## Vauxhall / Opel

Corса 1.0i, 1.2i with 'Easytronic' gearbox

CLTB 0011

# OPTIONAL ADAPTABLE CLUTCH KIT TO REPLACE SELF ADJUSTING UNIT

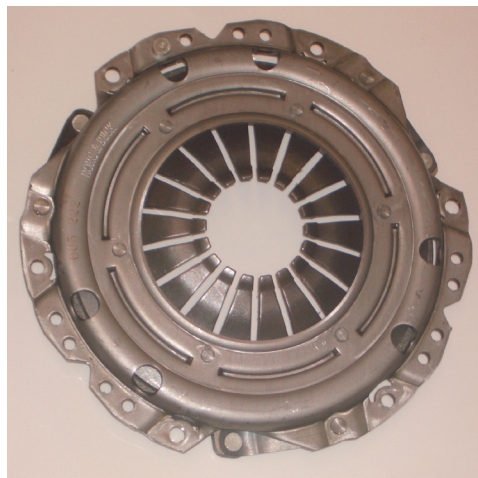
The self adjusting clutch (SAC) fitted to the models above (HK2097) is extremely susceptible to handling damage prior to fitment, specifically 'self adjust de-adjusting'.

Also, special tooling is required to mount the SAC to the flywheel.

A non self adjust clutch kit has been developed to counter these problems.

HK2097 now contains a 'traditional' type clutch cover assembly as shown below.
